Cambourne - Cambridge Bus Road (C2C) Independent Audit

Submission prepared by Colin M. Harris
25 April 2021 (v1)

This submission made to the Cambourne – Cambridge Bus Road (C2C) Independent Audit focuses on an alternative to the preferred scheme proposal by the Greater Cambridge Partnership.

Route Co-Aligned with A428 via Eddington
West Campus layout - key constraints

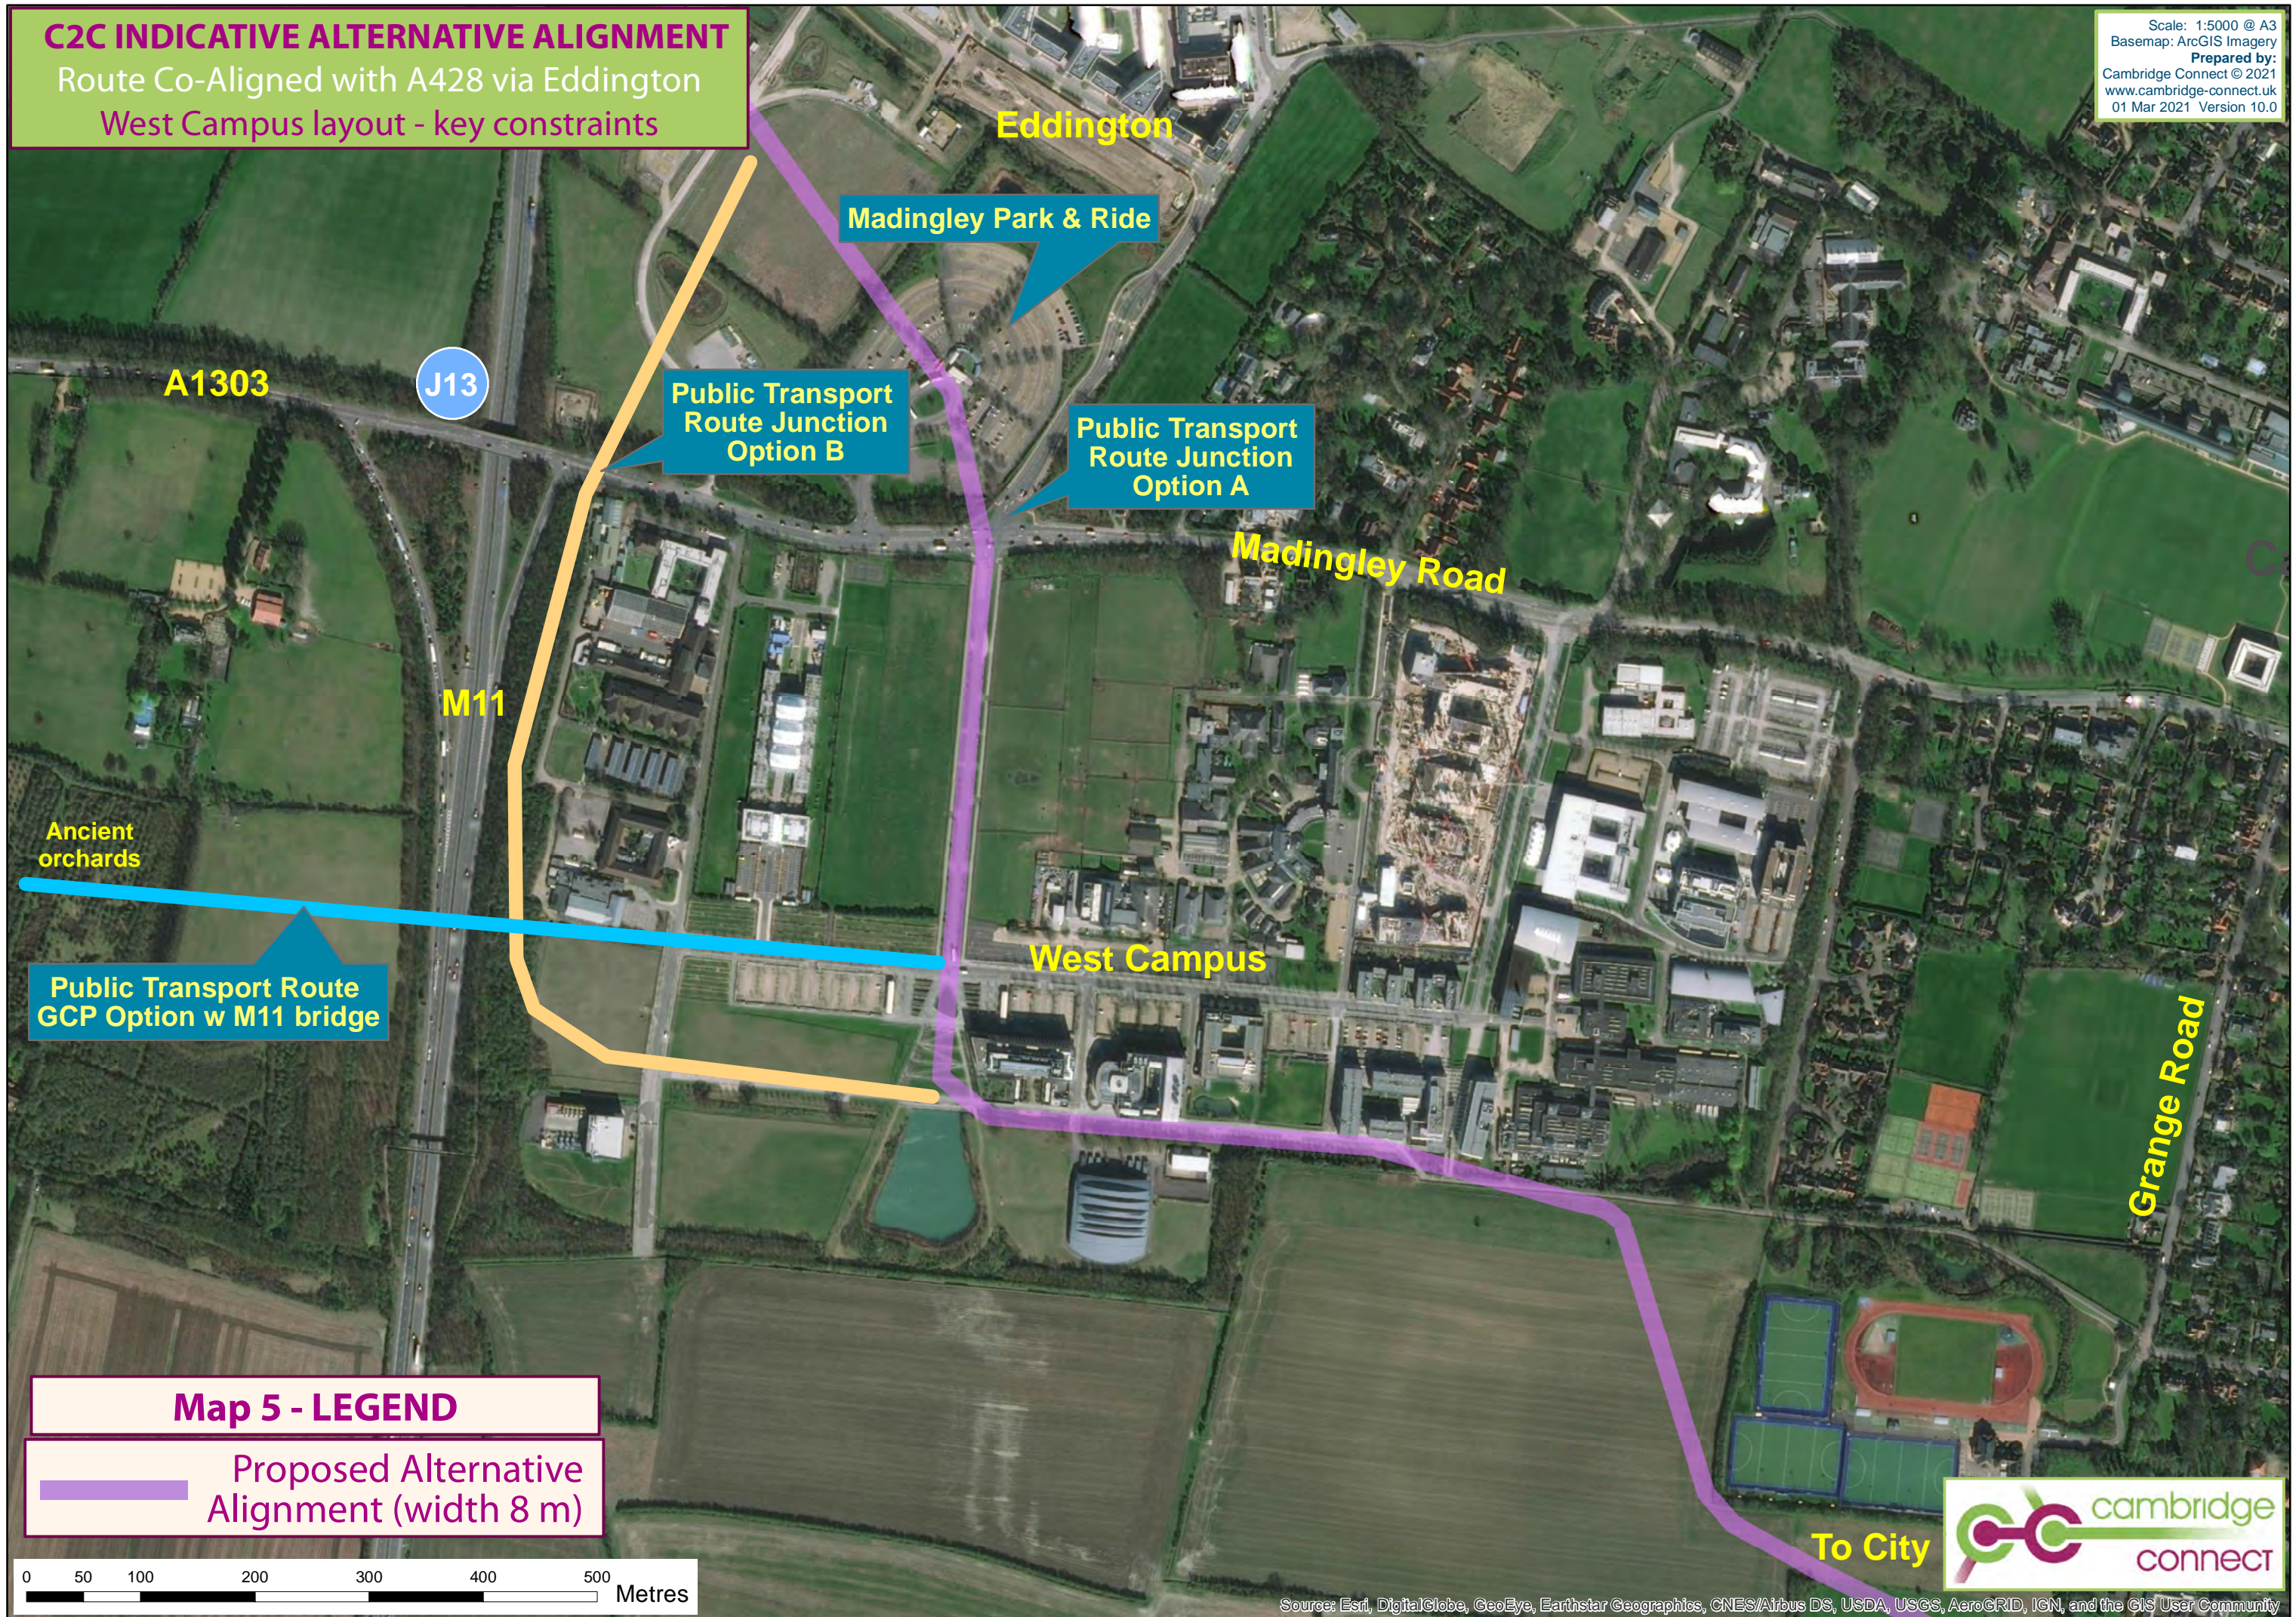
To Eddington 0.75km
 West Campus 2km
 Cambridge 4km

Schematic of bridges on A428 - south side, view west. Typical cross section. Dimensions in metres (approx).

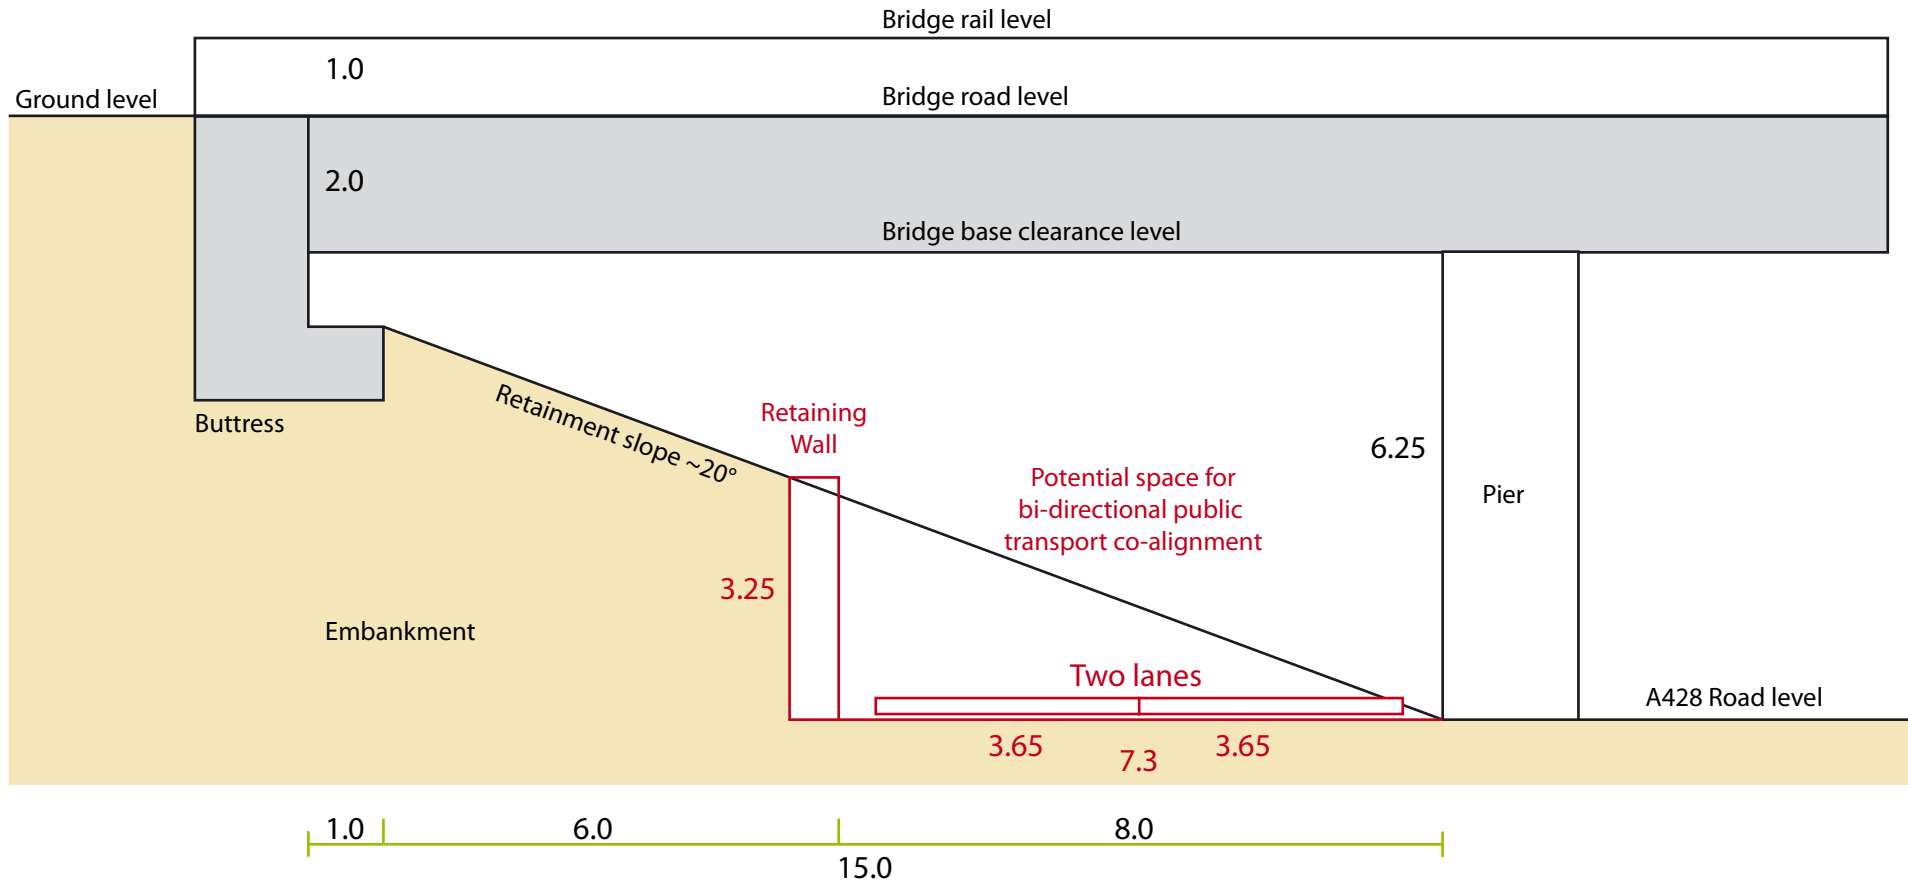
Madingley dimensions - 15.0 m from pier to buttress edge, 6.25 m height from A428 road level to clearance under bridge.

Church Road dimensions - 16.0 m from pier to buttress edge, 8.0 m height from A428 road level to clearance under bridge.

A428 MMR Offramp dimensions - 15.0 m from pier to buttress edge, 5.0 m height from A428 road level to clearance under bridge.
